SB-10056302-8220 Technical Service Bulletin

| SUBJECT: ELECTRIC POWER STEERING MOTOR SERVICE PROCEDURES – SERVICE MANUAL REVISION | | | No: TSB-14-37-003 |
| | | | MODEL: 2011-14 Outlander Sport/RVR |

This TSB updates the service procedures for the electric power steering (EPS) motor including adding a procedure for EPS motor replacement.

Removal
Motor

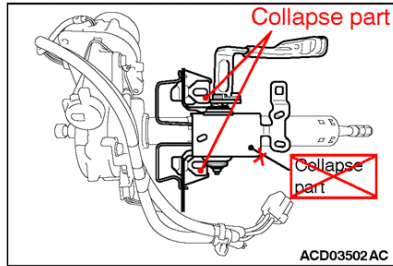
- The motor should be replaced together with the EPS-ECU.

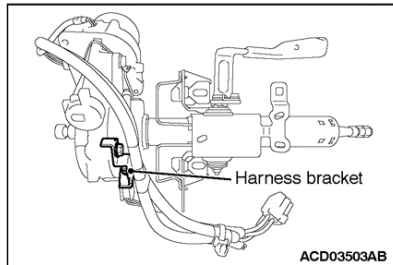
Do not remove the collapse part (shown in the illustration).

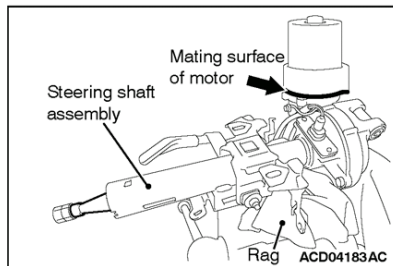
1. Remove the wiring harness bracket.
2. Remove the wiring harness.

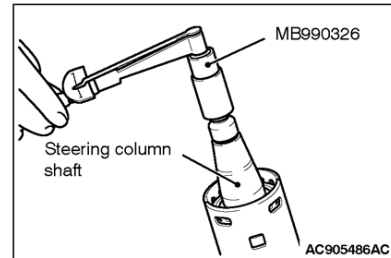
3. Clamp the worm housing of the steering shaft assembly in a vice.

- While clamping, be sure to keep the mating surface of the motor horizontal.
- Clamp the worm housing in a vice via rag to prevent damage.

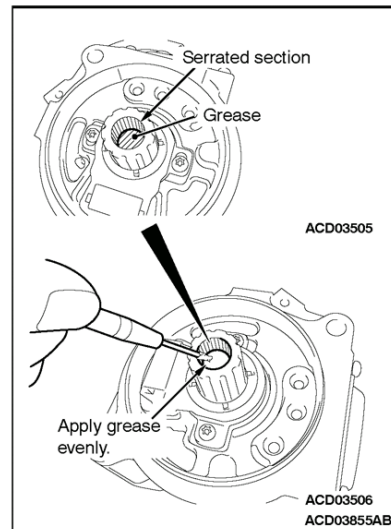
4. Install the nut to the end of the steering column shaft. Then use the preload socket (Special tool: MB990326) to rotate the shaft at a rate of one turn per 4 to 6 seconds, and then measure the total rotation torque.

- Be sure to make a note of the measured value, as the value will be used when installing the motor.
- Rotate by 180° in left and right directions from the neutral position, and measure the total rotation torque.

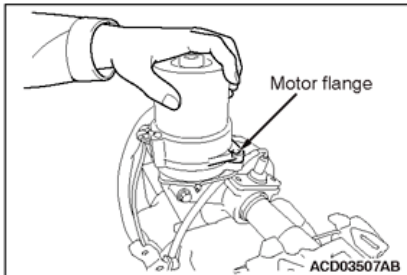
1. Take grease from the bottom of the motor boss and apply it to the serrated section.

Grease: Motor grease
Usage: 0.4 g

Be sure to apply grease evenly to prevent abnormal noise.

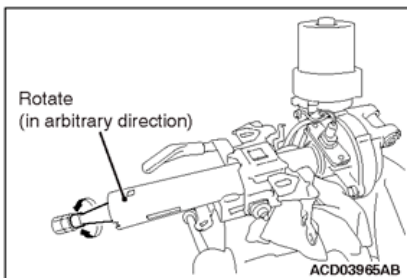
2. Insert the motor, and check that the motor flange moves with the bolts not tightened.

Be careful to avoid scratches or intrusion of foreign materials on the mating surface of the motor and the worm housing.

3. To prevent generation of abnormal noise by dislocation of the motor, temporarily tighten the motor mounting bolts alternately while rotating the steering shaft in the arbitrary direction at a speed of approximately one rotation per second.
4. Temporarily tighten the motor mounting bolts. Then, tighten them securely.
Tightening torque: $19 \pm 3 \text{ N}\cdot\text{m}$ ($14 \pm 2 \text{ ft}\cdot\text{lb}$)
5. Repeat the total rotation torque measurement performed in removal step 4.

If the total rotation torque fluctuation compared with the value measured at removal is $\pm 10\%$ or more, remove the motor again and repeat installation steps 2, 3 and 4.

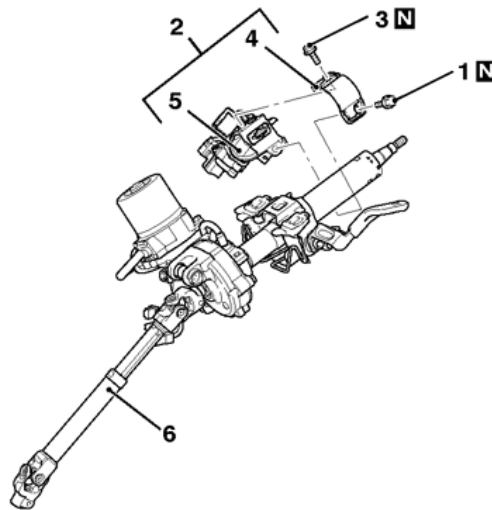
6. Connect the wiring harness.
7. Install the wiring harness bracket and harness clip.

Tightening torque: $19 \pm 3 \text{ N}\cdot\text{m}$ ($14 \pm 2 \text{ ft}\cdot\text{lb}$)

NOTE: Make a mark beside the label with a black felt pen to indicate that the motor has been replaced.

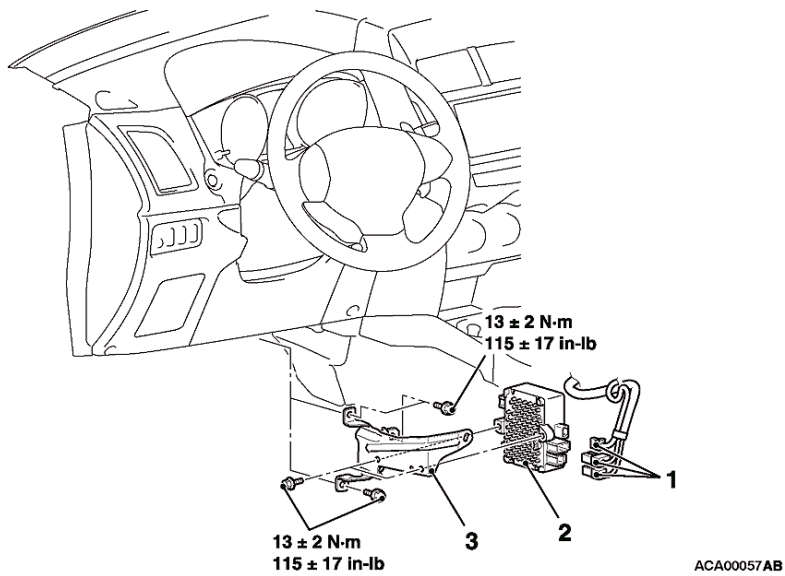
• The EPS-ECU should be replaced together with the motor.
